**Seattle  
Design  
Commission**

**MINUTES OF THE MEETING**

**February 07, 2008**

Projects Reviewed

Figure 3: Fire Station 27 elevations

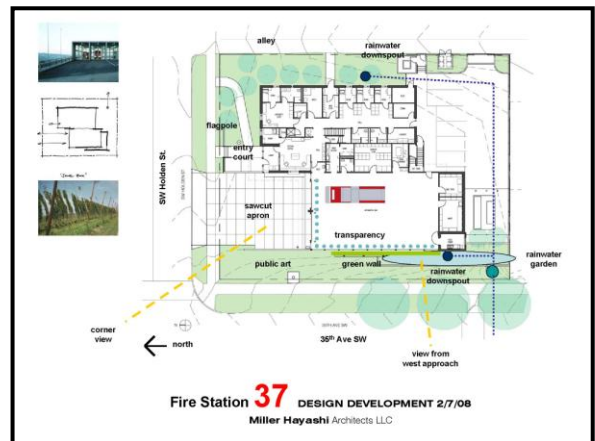
- What are the angles above the apparatus bay doors in the north elevation?
  - They are part of the structural tension system.
- Are there trusses in the apparatus bay?

- What is the roof protrusion in East elevation?
  - It is a skylight on the roof.
- The building will have a dramatic civic presence, and should embrace the corner despite the size of the structure.

- The choice in color, materials, and doors are all appreciated. Due to beauty of materials, the team shouldn't cover up too much of the wall with hops.

- The balance of the screen behind the hops is unsettling, front corner could open up to allow more transparency.
- The hops green screen could also angle back at south end to provide view into apparatus bay. Low glazing could be used on the bottom window.

**Figure 7: West and South Elevations**

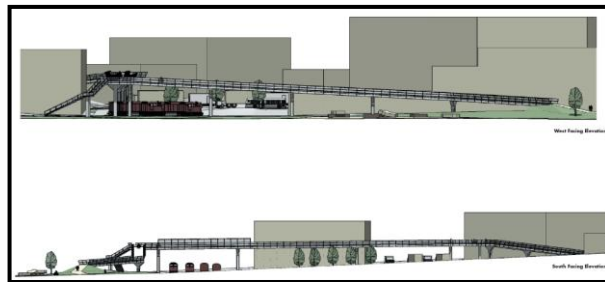
- May be able to strengthen belvedere with potential seating area, lowering the railing might then be possible.
- Avoid freeway signage on bridge
- The handrails are woven wire mesh, is that tube steel?

- Yes, probably a dark color. Mesh may be galvanized or painted. May be connection to sculpture park, but want to differentiate.
- The railings are 4'6" for bikes, even though people are walking them?

- Bicyclists will be riding across.
- Keep handlebar placement in mind, may cause conflicts.
- Concerned with addition of handrail, youth using that to get on horizontal portion.

- Appreciate helping people across. Perhaps have less of an angle
- Appreciate the simplicity of the railing, also find it somewhat brutal. Phoenix is an example of different treatments that can be done. Skaters love railings and ramps, could cause conflicts, so keep in mind. Belvederes are important juncture points and should be celebrated.

**Figure 9: Project Cross Section**

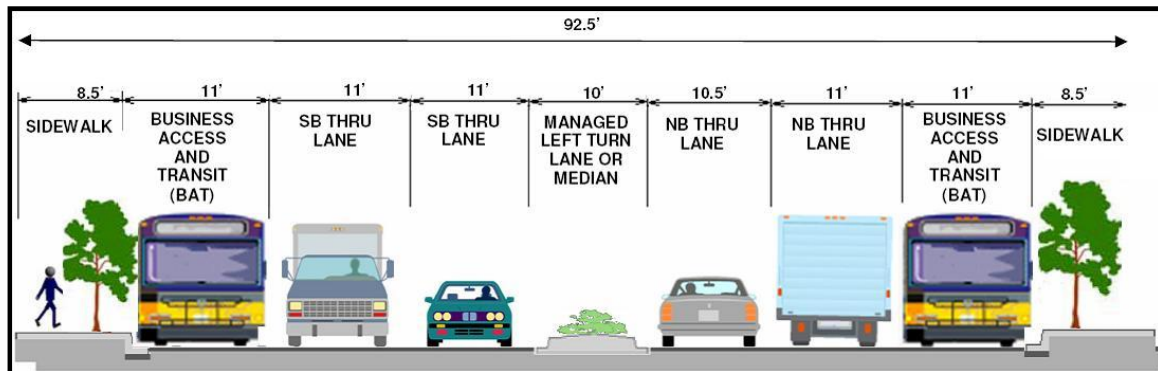
**Comment:** The proposed design isn't possible in this area. Sidewalks still remain at 12' and bus lanes at 13'. No amendment has been filed by Mayor. The current appeal is on that larger width, but no change to the DNS has been made. In addition, the project has ignored neighborhood concerns. There are currently 1120 multifamily units being built along Linden; no provision for those who travel to Aurora to access sidewalk or bus services.

- The smaller sidewalk is at the detriment of the pedestrian.
  - Where people are waiting for buses the ROW should be kept to provide shelter.
- Linden will be constructed as a pedestrian street

- Is WSDOT onboard with lane change?
  - They recognize the compromise.
- Safety over amenities, but bus lane needs to be wider. This is one area of Aurora that has many businesses.
